Final Drainage Report – Early Grading Permit

Waterview East Commercial El Paso County, Colorado

Prepared: July 5, 2023

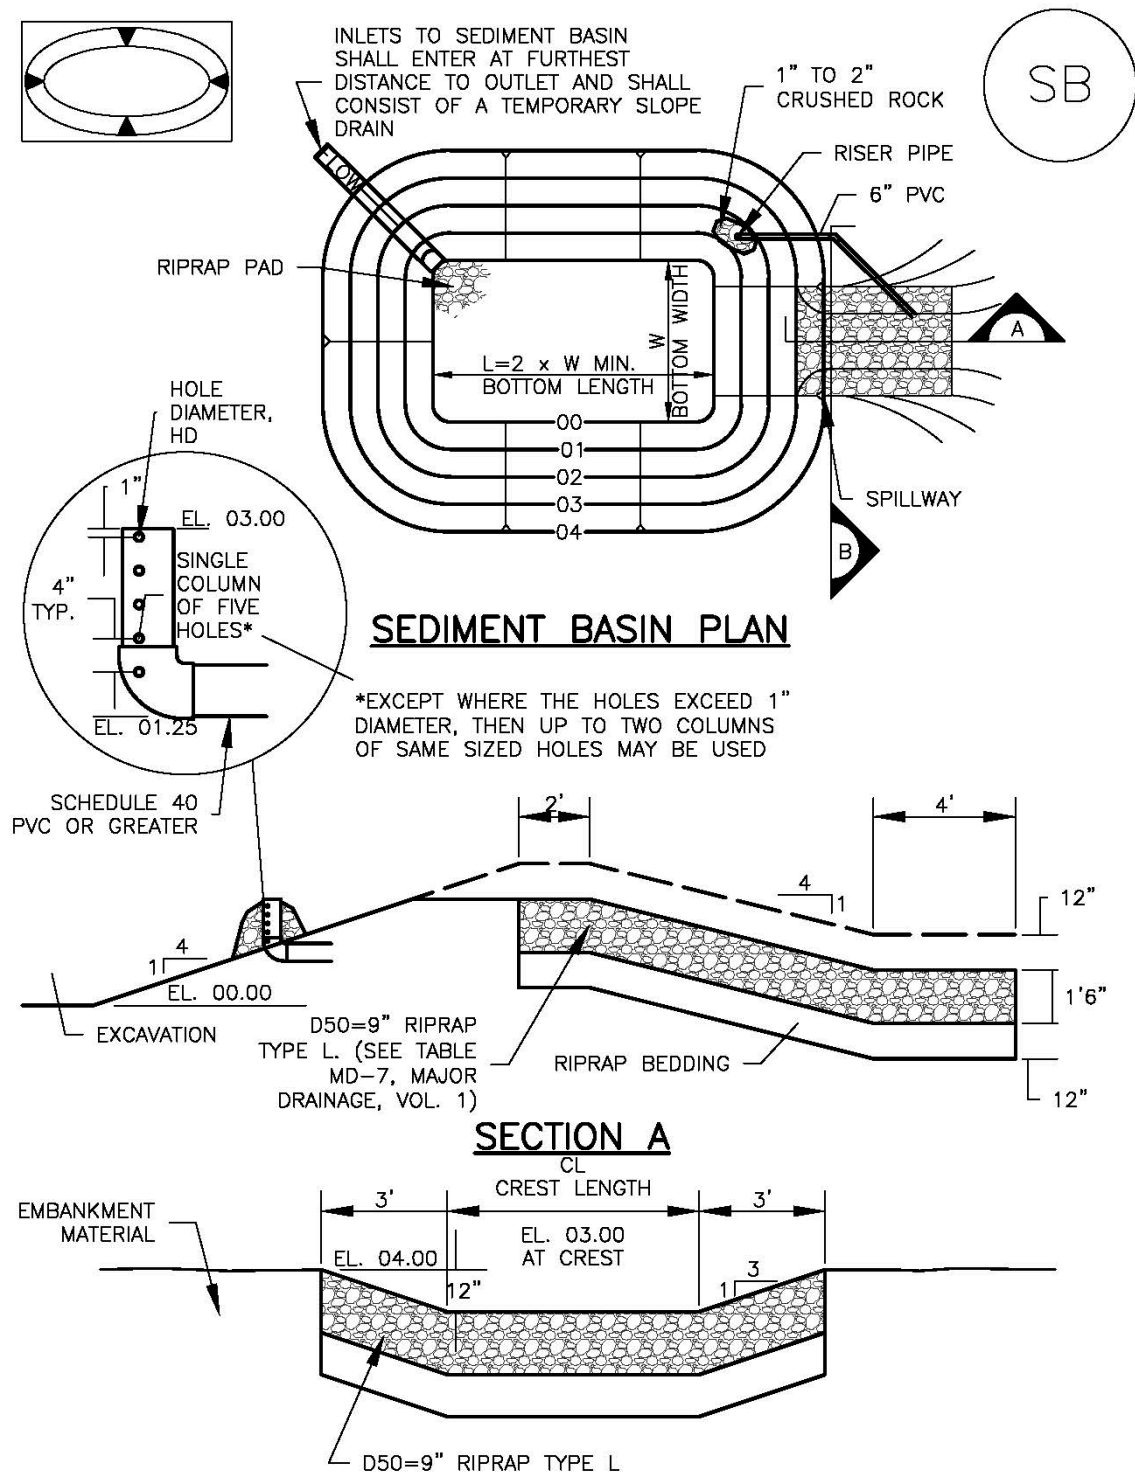
Unresolved Comment:
- Provide sizing calculations for
TSB ponds.
